**TCP/11/16(548) – 17/00841/IPL – Erection of a  
dwellinghouse (in principle) on land 70 metres south east  
of New Mains Farmhouse, Inchture**

**PAPERS SUBMITTED  
BY THE  
APPLICANT**

This Planning Appeal has been submitted on behalf of the applicant, Mr James Hamilton and relates to a Planning Application for the erection of a dwellinghouse (in principle) at land 70m south east of New Mains Farmhouse, Inchture.

proposed site plan 6542.500.108  
1350 @ A2

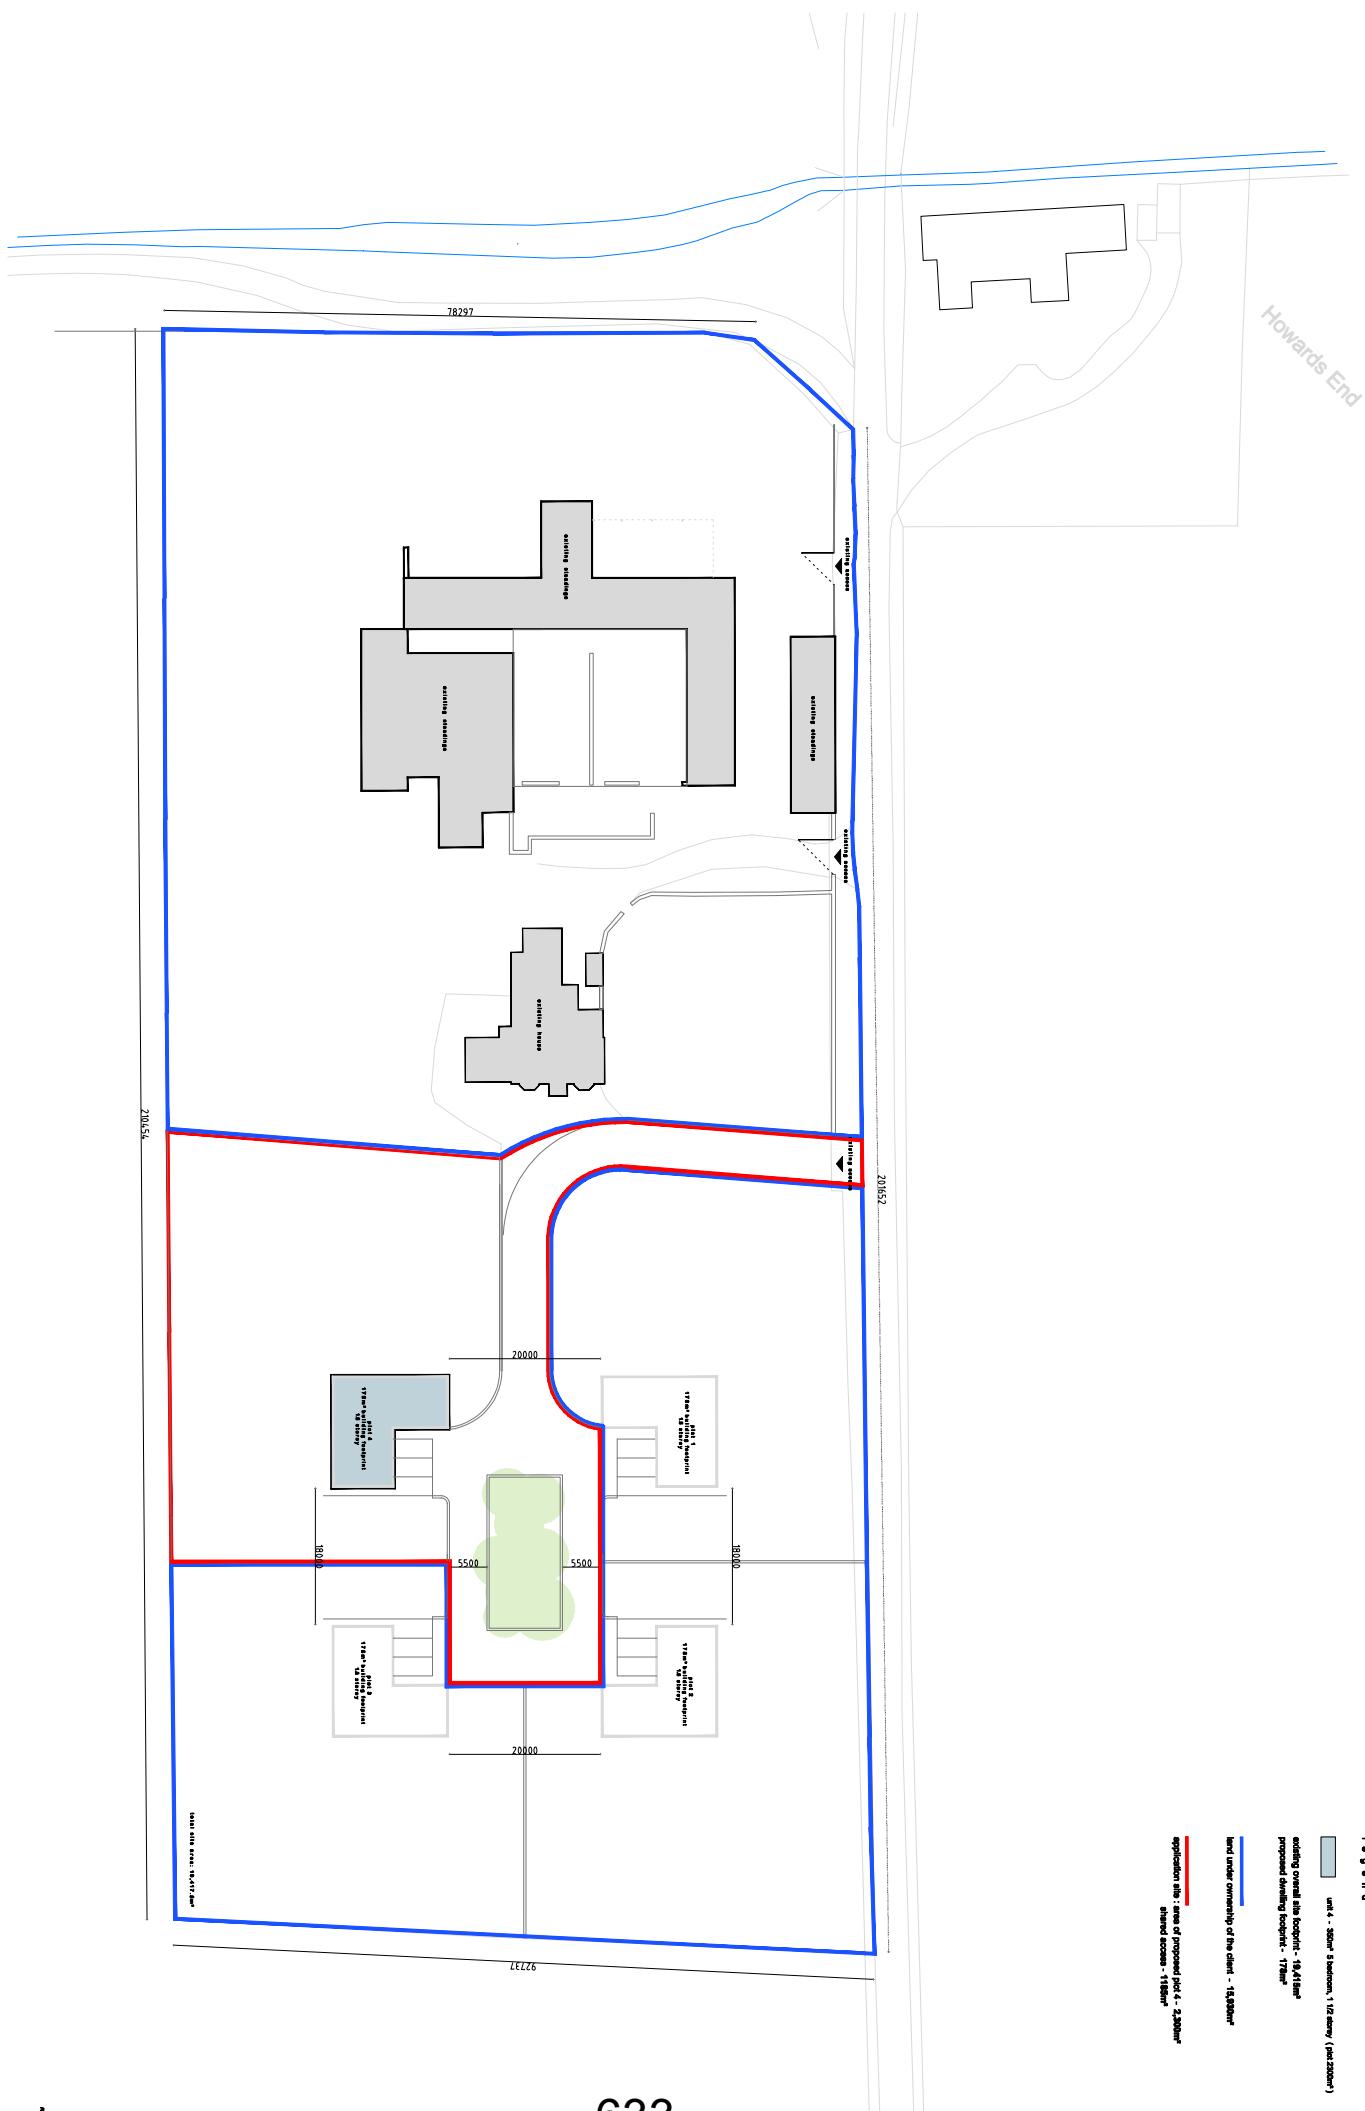
The revised proposed site plan in Document 4 demonstrates that the existing landscape buffer is 5m wide and comprises of a combination of trees and shrubs at its narrowest. Document 4 also illustrates our proposal to enhance the landscape buffer through additional tree planting which will increase the width and depth of the existing landscaping containing the site further addressing the Case Officers concerns.
